<h2>Engagement Report</h2>

Engagement report – Cycling connection between King and College Streets

Appendix A: feedback left on interactive map

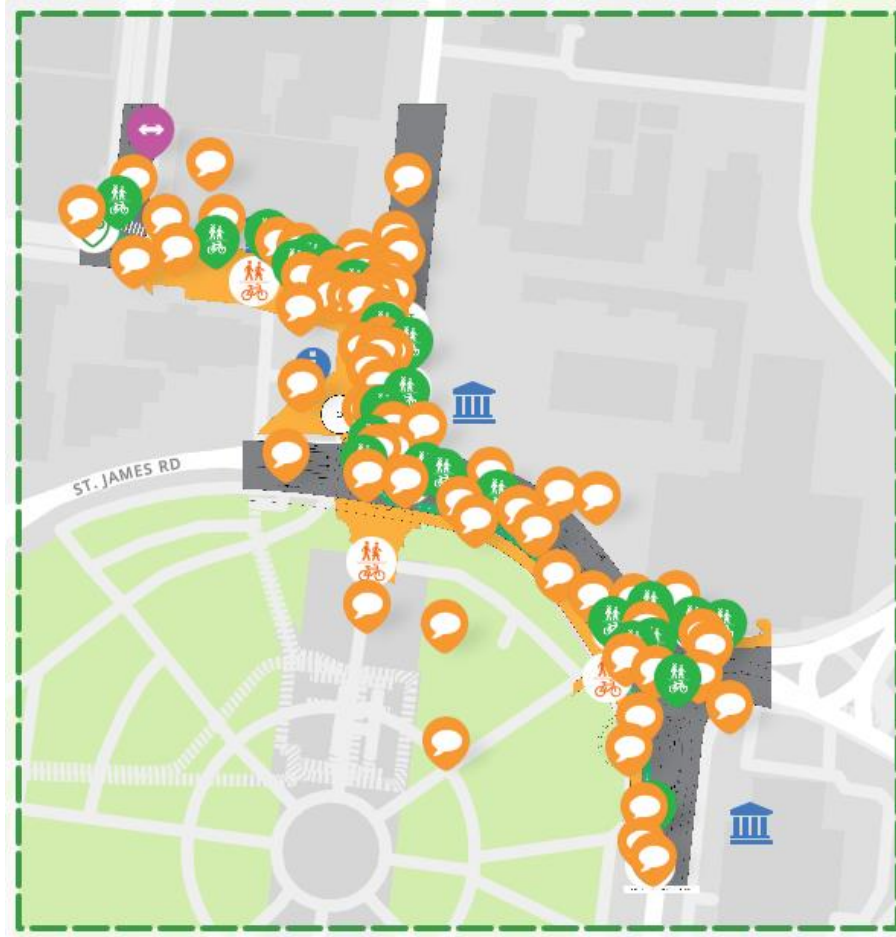
Location	Comment	CoS Response	Count	Up	Down
All	Support		27	337	2
Queen's Square	Physical separation between people walking and riding is needed	The section through Queens Square will remain as a shared path area, with new pavement markings to make clear that pedestrians have priority.	25	1	0
Queen's Square	Please address the steps/lip of the stairs.	An upgrade to Queen's Plaza is not part of the project scope, however pavement marking will be considered where needed.	6	89	0
College Street south of Prince Albert Road	Provide gap in the barrier for people riding to continue into Prince Albert Road	This will be resolved during design development.	3	27	0
Macquarie Street	Allow for people riding north to join Macquarie Street traffic lanes	This will be resolved during design development.	3	14	0
Queen's Square	Have separation between people walking and riding at the same grade. Example in Bondi Junction	The section through Queens Square will remain as a shared path area, with new pavement markings to make clear that pedestrians have priority.	3	33	1

Macquarie Street	Extend the cycleway up Macquarie Street	A cycleway to Macquarie Street north is not part of the project scope.	2	33	1
Macquarie Street at Hyde Park	Make sure the barrier extends all the way to the traffic lights	This will be reviewed during design development.	2	44	0
Macquarie Street at Hyde Park	Use green paint throughout	The design will use green cycleway paint on on-road sections at vehicle conflict points, as specified in guidelines and as on other cycleways.	2	35	0
Macquarie Street	Place additional sensors to trigger bike signal prior to the intersection so as avoid missing their turn	This will be reviewed during design development.	2	9	1
College Street at Prince Albert Road	Have a turning lane into Prince Albert Road and start the 30km/h area at the intersection	This will be reviewed during design development.	2	30	0
All	Make sure there is a fair traffic light phasing for people walking and riding	This will be reviewed during design development.	2	33	0

Queen's Square	The shared area is good as it is, does not need green paint. Work needs	A public domain upgrade to Queen's Plaza planned in future. There will not be green paint in	2	3	0

Location	Comment	CoS Response	Count	Up	Down
	to be done on the lip/steps	Queens Square – it will remain shared path. Markings will be considered where there are lip/step.			
Macquarie Street at Hyde Park	Make the intersection raised and continuous to ensure priority for people walking and riding. Eg Greenknowe and Macleay	A full intersection upgrade is not part of the project scope.	1	18	0
Macquarie Street at Hyde Park	Build out the footpath at the intersection on the northern edge of Hyde Park	A footpath upgrade in that area is not part of the project scope.	1	31	2
St James Road	Realign the lanes on St James Road	Realignment of travel lanes is only considered where needed	1	11	0
Macquarie Street at Hyde Park	Ensure easy access from the park on to the cycleway at both St James Road and Prince Albert Road	This will be reviewed during design development.	1	21	0
College Street at Prince Albert Road	Provide waiting space for people riding to cross and join Prince Albert Road	This will be reviewed during design development.	1	17	0

College Street at Prince Albert Road	Continue barriers but retain a gap for people to cross	This will be reviewed during design development.	1	14	0
Phillip Street	Make the crossing raised	A crossing upgrade in that area is not part of the project scope.	1	2	0
Macquarie Street	Automate bike signals	Bike signals at intersections are triggered via sensors on the cycleway and, in the CBD, automatic during daytimes during the week.	1	2	0
Macquarie Street	it would be safer for the curb not to have a sharper corner to limit potential confusion for left-turning motorists	This will be reviewed during design development.	1	18	0
Hyde Park	Remove redundant shared zones and clearly demarcate which paths inside the park are shared zones and which aren't	All paths in Hyde Park are shared paths to enable people to reach the various parts of the park.	1	9	9
Queen's Square	Provide shared path signage and direct people riding to dismount if there is a lot of people walking	When a place is very crowded, many people riding find it easier to walk their bike, but this might not be suitable for people with disabilities, mobility difficulties or children.	1	2	10

Location	Comment	CoS Response	Count	Up	Down
Queen's Square	Provide shared path signage	The project will include shared path signage and pavement markings.	1	36	2
All	Make sure that cycleway access is safe and entry/exit is not too sharp	This will be reviewed during design development.	1	12	0
All	Retain the existing shared paths even adjacent to the cycleway	This will be reviewed during design development.	1	17	0
Queen's Square	Avoid the use of bollards to demarcate the shared area	This will be reviewed during design development.	1	1	0
Queen's Square	Connection through the square should avoid any existing bollards or poles	This will be reviewed during design development.	1	1	0
Macquarie Street at Hyde Park	Configure traffic lights so that people riding southbound have two opportunities to cross. First, green light for southbound cyclists turning east along the cycle path. Second, green light for southbound cyclists continuing south into Hyde Park	This will be reviewed during design development.	1	2	0

Art Gallery Road	Suggest traffic treatments outside of the Gallery	Art Gallery Road is not part of the project scope.	1	0	0
Macquarie Street at Hyde Park	Make the intersection scatter crossing and provide more time for people walking and riding to cross	This will be reviewed during design development.	1	1	0
All	Open sections as soon as they are complete, don't wait for full completion like College Street	The cycleway will be open once it is completed and safe to do so (sometimes there is a delay waiting for the signals to be changed).	1	5	0
Prince Albert Road	Extend the shared path on the north side of Prince Albert Road	Prince Albert Road north is not part of the project scope	1	7	0
Queen's Square	Widen the footpath next to the statue for people walking	The project will provide a separated cycleway beside this location, so that the footpath near the statue is only used by people walking.	1	6	0
